Reply to Referee #4' s comments

Title: A flux tower site attribute dataset intended for land surface modeling

No.: essd-2024-77

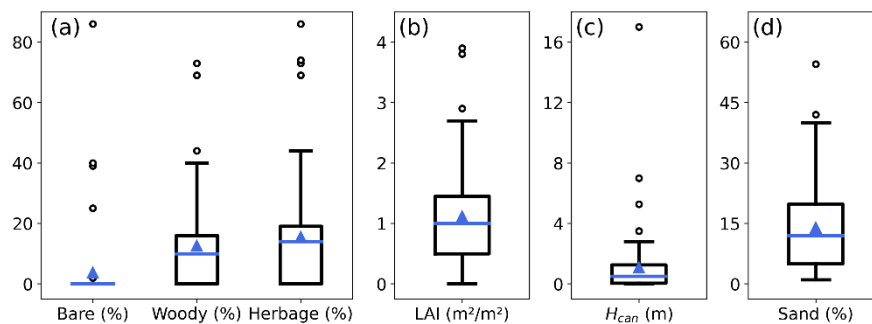
Comment 4 (L92): "Three global datasets were used to complement attribute data of sites lacking site-observed FVC, LAI, and soil texture." It's great to analyze the uncertainty by using global datasets to fill site data. How accurate are these global datasets? The authors could analyze the consistency between sites with complete attributes and the corresponding global datasets. This information would be valuable for readers to understand the uncertainties introduced by using global datasets.

Response 4: We fully agree with your suggestion. Other reviewers have raised similar concerns requiring cross-checking of filled data to quantify their uncertainties.

We provide the quantification of uncertainties in the final dataset resulting from data filling. After careful consideration, the quantification of discrepancies between site data and filled data has been added to Sect. 3.2, illustrating the uncertainties of the filled data. The added information is as follows.

Figure 4 quantifies the differences between site data and filled data at all sites for which both data sources are available, illustrating the inhomogeneities in the final dataset due to data filling. The differences in vegetation cover (including bare soil, woody, and herbaceous vegetation) generally fall within 20%, with a minority of sites exceeding 40%. The mean and median LAI differences are approximately 1 m²/m². Canopy height deviations are primarily within 2 m, although a few sites exceed 4 m. Differences in sand content typically remain within 30%, with both mean and median differences below 15%. The quantification indicates that the filled data are generally reliable across most sites.
